THE HOTEL AT FOUNDRY PLACE, "LOT 3": 165 DEER STREET, ASSESSORS MAP 125 LOT 17, AND RELATED IMPROVEMENTS TO LOTS 2, 4 & 5

SITE PLAN REVIEW

SITE PLAN REVIEW
FEBRUARY 6, 2018

**SITE PLAN -
DETAIL
(SHEET 2 OF 3)**

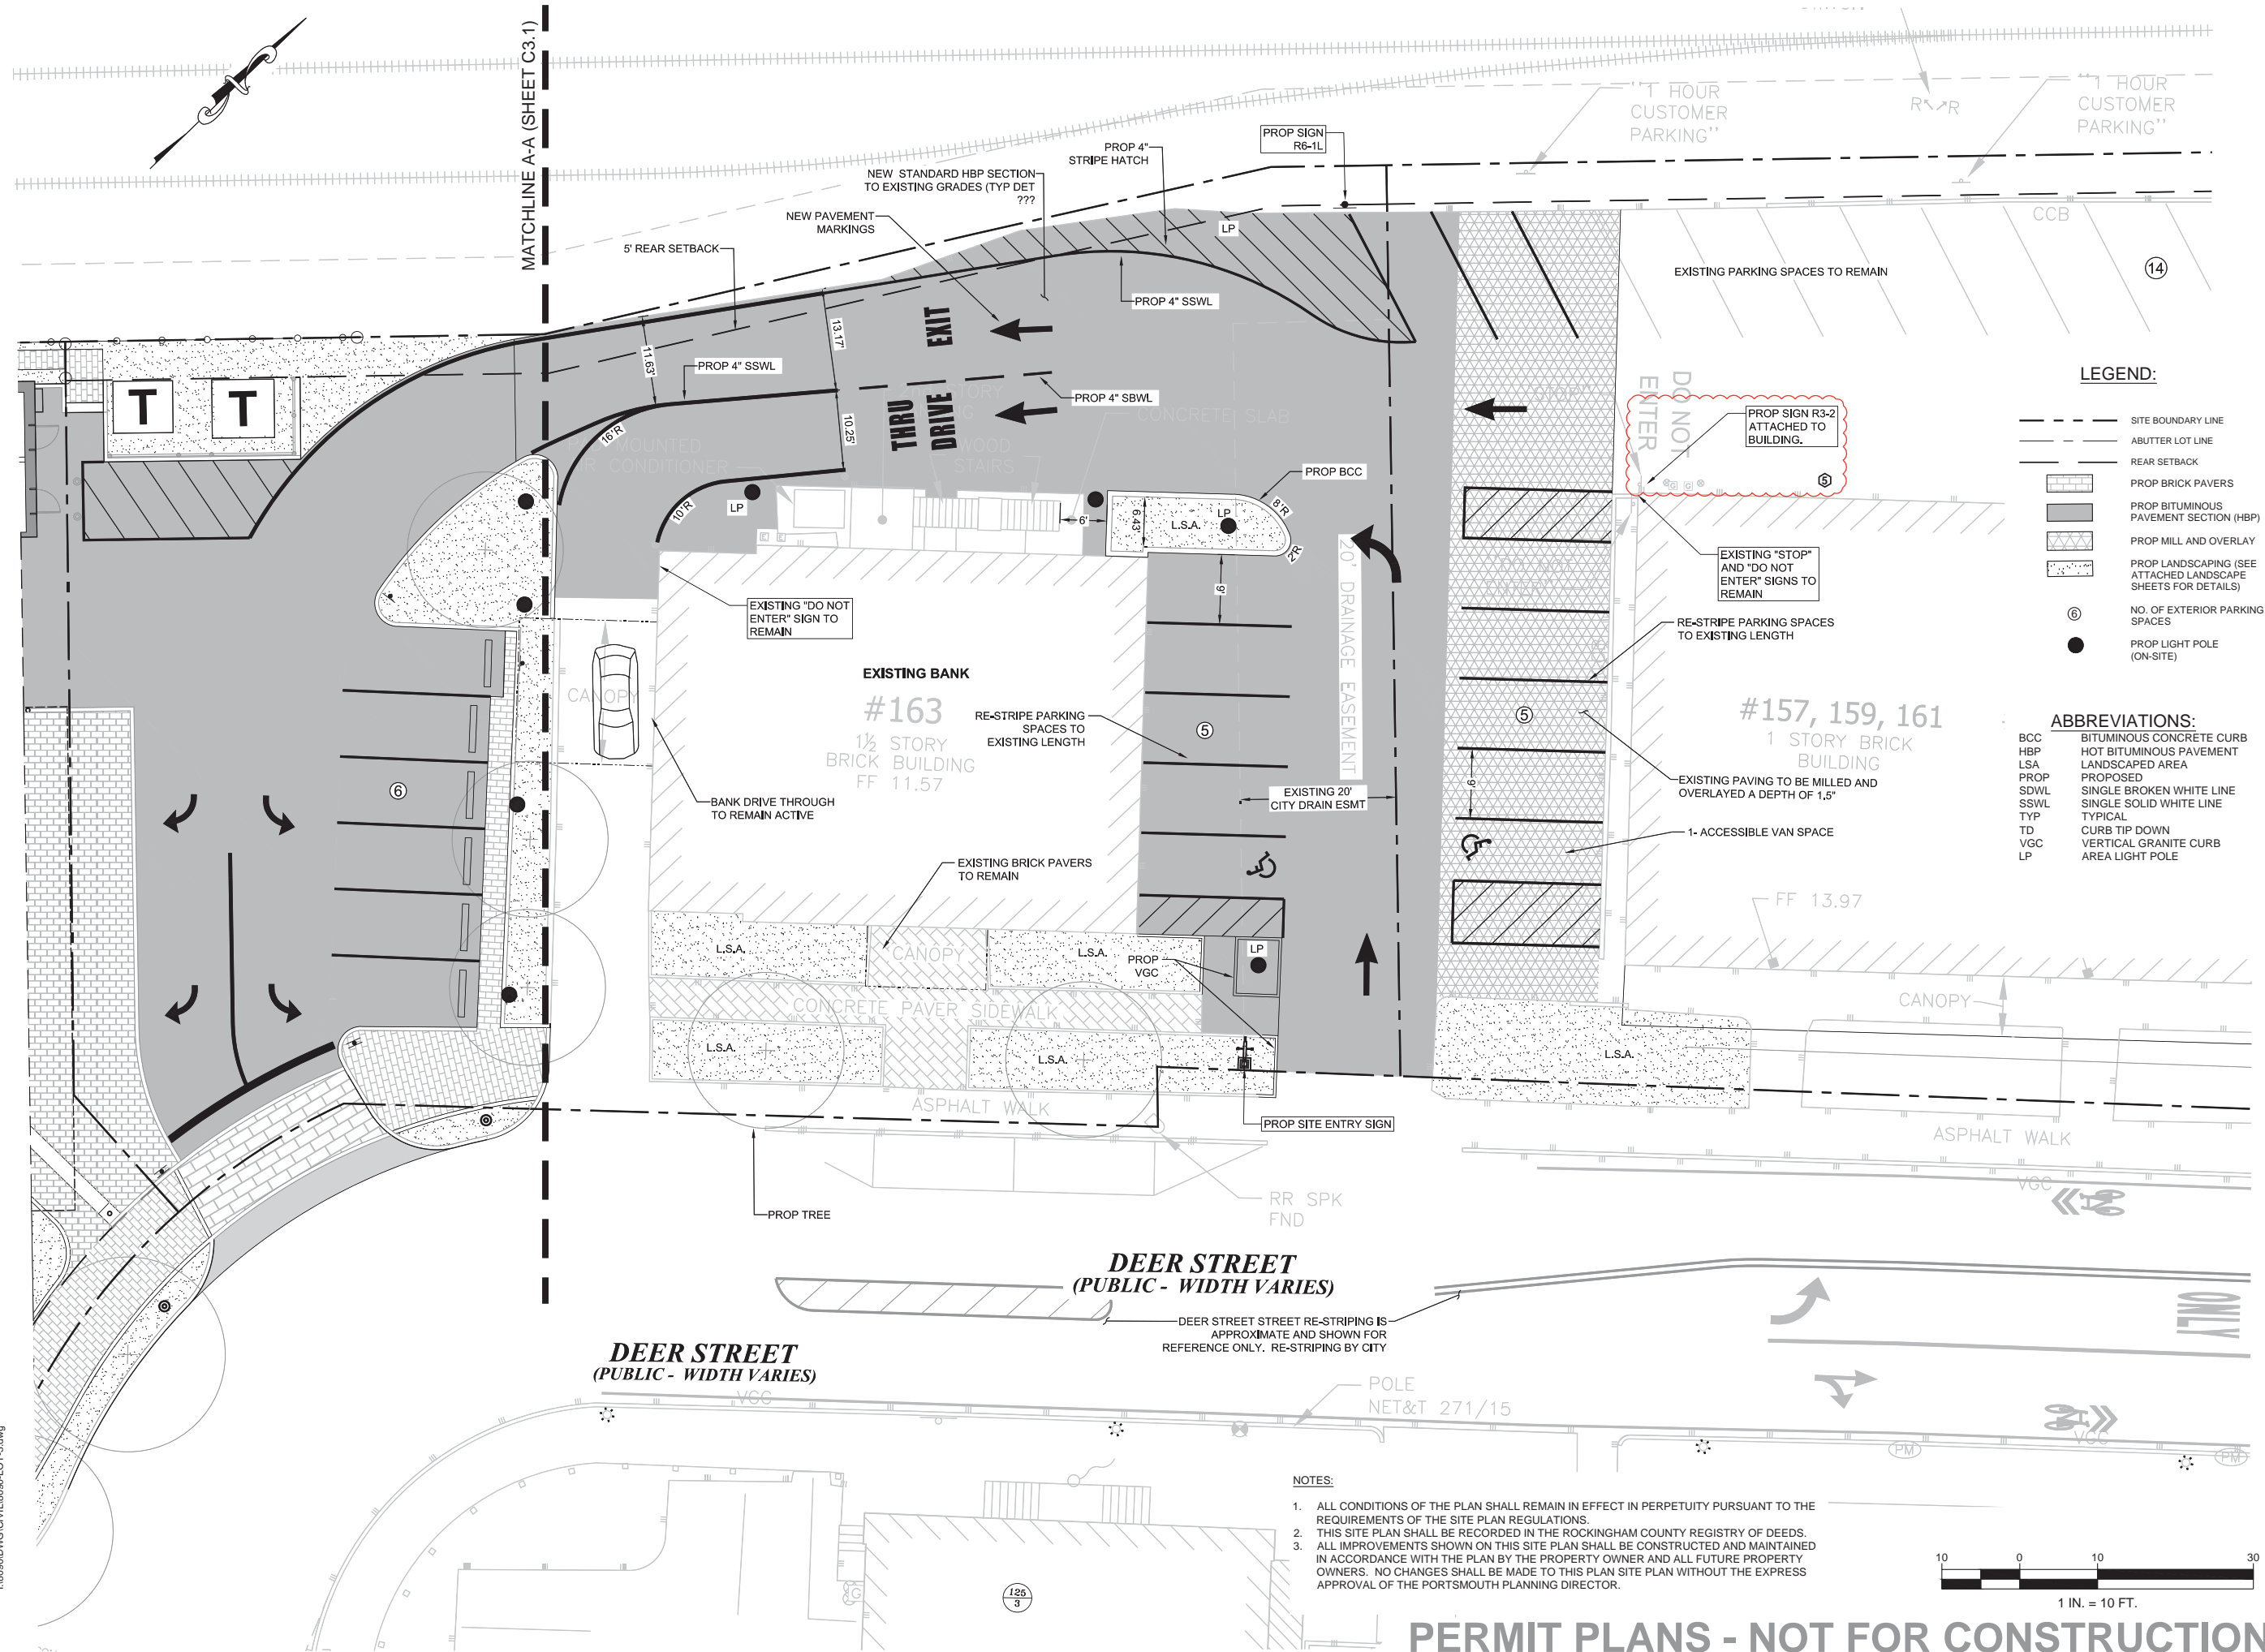
Response: A “no-left turn sign” sign will be erected as shown on the attached Figure C3.2 that informs drivers exiting from behind the existing bank building that they cannot take a left and exit the proposed one-way entrance.
